# Stormwater Division

**General File ID or BMP ID:** PC001

Mews at Williamsburg

Re: Mews Subdivision  
Stormwater Management Facility (PC 001)

GRADING, DRAINAGE, & EROSION CONTROL PLAN  
**THE MEWS AT WILLIAMSBURG**  
 OWNER/DEVELOPER:  
 A JOINT VENTURE OF  
 FIRST AMERICAN DEVELOPMENT GROUP, INC., AND TRIAD DEVELOPMENT CORP.  
 JAMES CITY COUNTY, VIRGINIA  
 BERKELEY DISTRICT

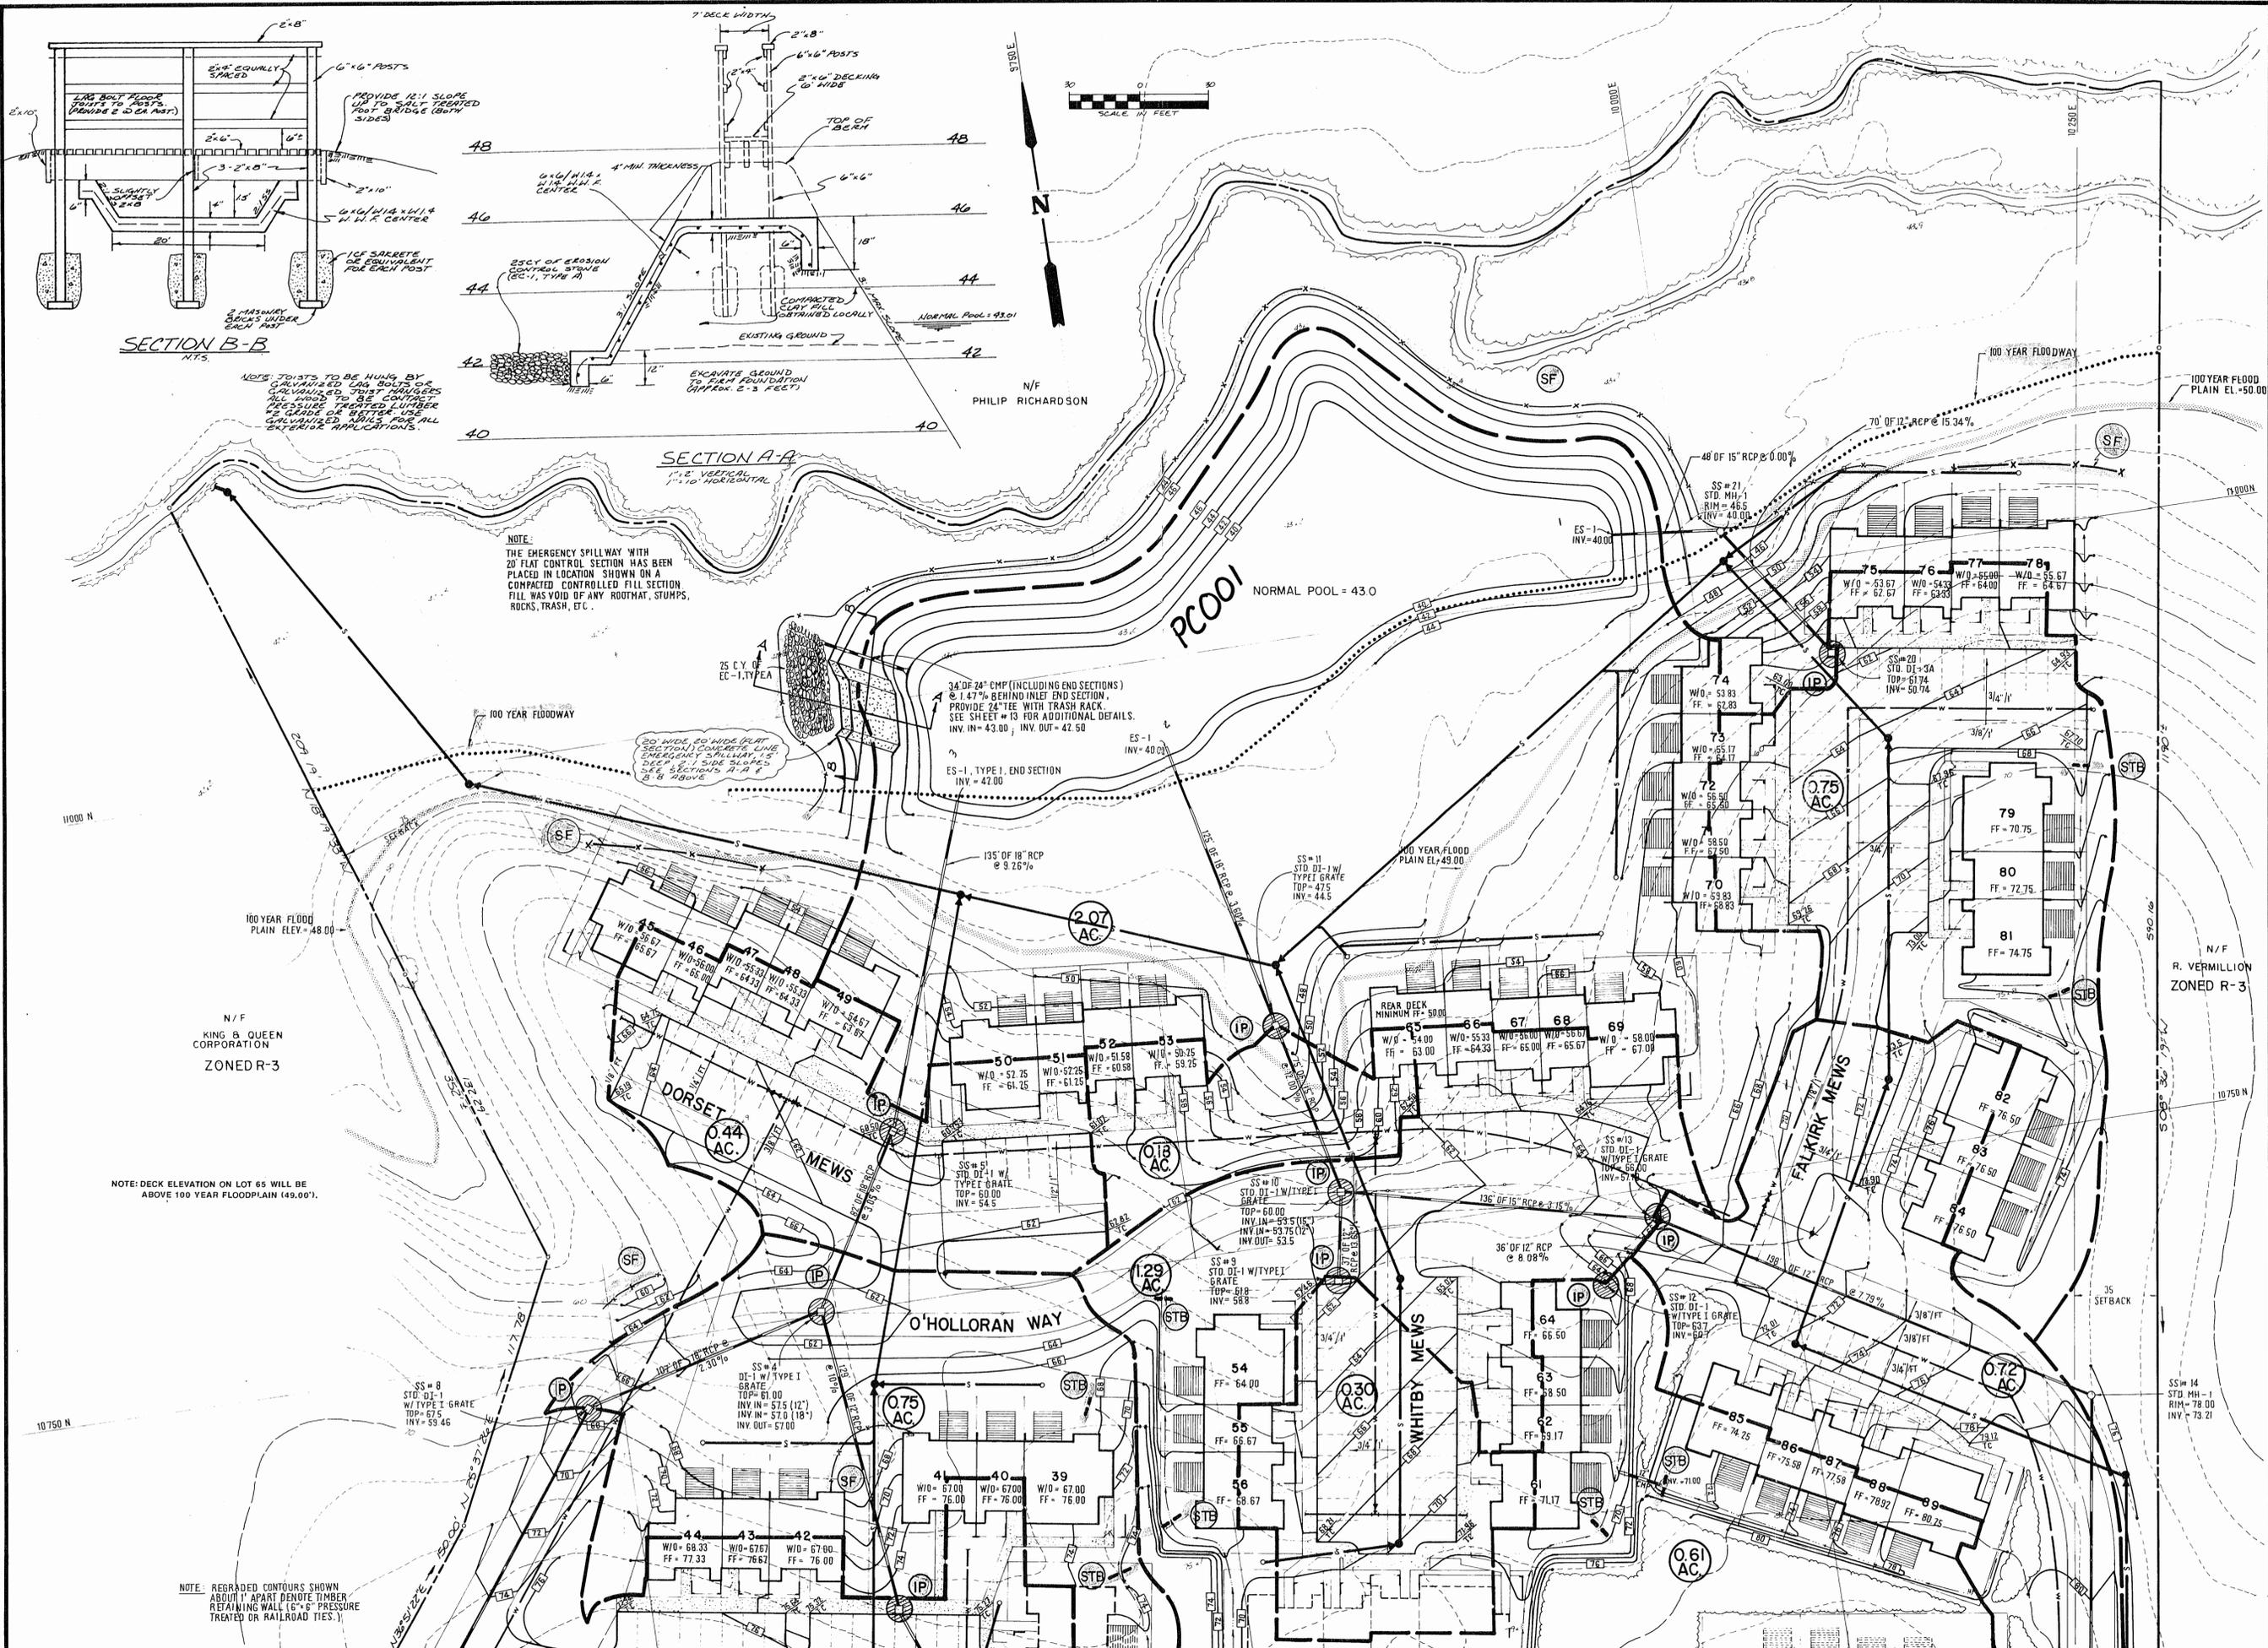
## 1. Avg Elev of Silt in Pond

41.5	70.2
42.0	40.5
41.0	41.2
40.6	<u>40.9</u>
40.2	1170.2
40.7	
41.1	$\frac{1170.2}{29 \text{ Pts}} = 40.35$
40.0	
40.3	
40.1	
40.0	
40.2	
40.0	
39.7	
40.2	
39.7	
40.1	
40.2	
39.9	
39.7	
39.6	
39.9	
40.3	
40.1	
40.3

2. Normal Pool = 43.22

3. ∴ DEPTH = 43.22

4. PLAN REQUIRES 43.0

∴ POND NEEDS TO BE DEEPER

NORMAL POOL  
FILLED 75%+
